Access Compliance Report Public Rights-of-Way (Curb Ramps)

Main Street: **ORANGE_AVE** Cross Street: **GILBERT_ST** Location: **NW**

ADA ID: **RPRK210927110852** Ramp Type: **Type 1 - Perpendicular Diagonal Initial Pass/Fail: Pass** Overall Compliance: **No** Severity Score: **0**

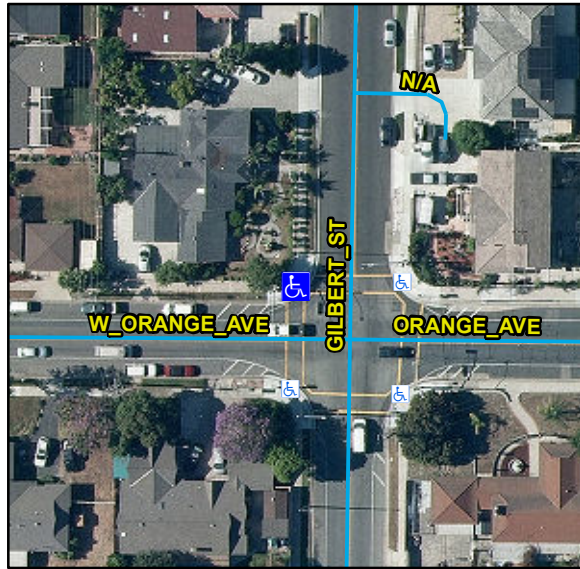
Possible Solutions:
Remove & Replace Landing. Gutter Ponding Observed.
